2200557

**Section 4.55(1A) Modification Application 16
The Star Casino – Former Part 3A Approval MP08_0098**

This application has been prepared by Ethos Urban on behalf of The Star Entertainment Group Limited (The Star), pursuant to section 4.55(1A) of the Environmental Planning and Assessment Act 1979 (EP&A Act) to modify Development Consent, former Part 3A Approval MP 08_0098 relating to 80 Pyrmont Street, Pyrmont (the site).

Figure 1 Location of Level 17 balconies subject to modification

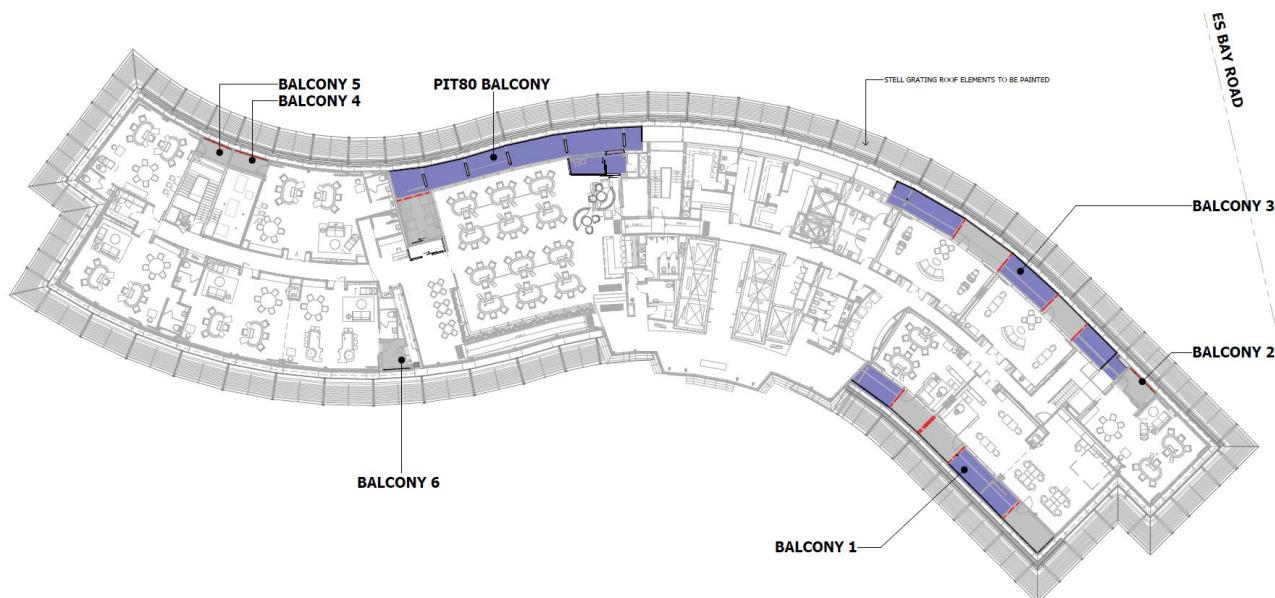
A series of upgrades and expansions of Level 17 outdoor balconies also form part of this modification. Locations of the subject balconies are provided in **Figure 1**, with the detailed changes provided in **Table 1**. As per the definition of Gross Floor Area (GFA) under the Standard Instrument, balconies with an outer wall under 1.4m are not considered as floor space and therefore the amendments will not result in an increase of GFA.

Balcony	Changes
Balcony 1	<ul style="list-style-type: none"> • New floor infill to match existing balcony levels. • Existing balustrade returns to be removed. • Existing floor to be re-surfaced to match new. • Discrete safety lighting to balcony edge. • New batten screen between VIP rooms. • New solid infill to existing framing for weather protection. • New batten screen between VIP rooms.
Balcony 2	<ul style="list-style-type: none"> • Discrete safety lighting to balcony edge. • New 'window' style opening to existing solid wall to achieve open air requirements. • Glazing panels of existing balustrade to be replaced with perforated metal.
Balcony 3	<ul style="list-style-type: none"> • Discrete safety lighting to balcony edge. • New floor infill to match existing balcony levels. • Existing balustrade returns to be removed. • Existing floor to be re-surfaced to match new. • New floor infill to match existing balcony levels. • New solid infill to existing framing for weather protection. • New batten screen between VIP rooms.

Balcony 4 & 5	<ul style="list-style-type: none"> • Discrete safety lighting to balcony edge. • Glazing panels of existing balustrade to be replaced with perforated metal.
Balcony 6	<ul style="list-style-type: none"> • Balustrade infill to match existing.

Balcony	Changes
Balcony Pit 80	<ul style="list-style-type: none"> • New balustrade around existing framing for head height clearance. • New balustrades. • Existing angled structural framing removed. • Existing balustrades removed. • Existing door to breakout space to be replaced with sliding door. • New airlock and new sliding door. • New floor infill to be flushed with Pit 80. • Discrete safety lighting to balcony edge. • Existing façade removed and setback. • Proposed new glazed wall for airlock. • New airlock with sliding doors. • New façade and balcony flooring.
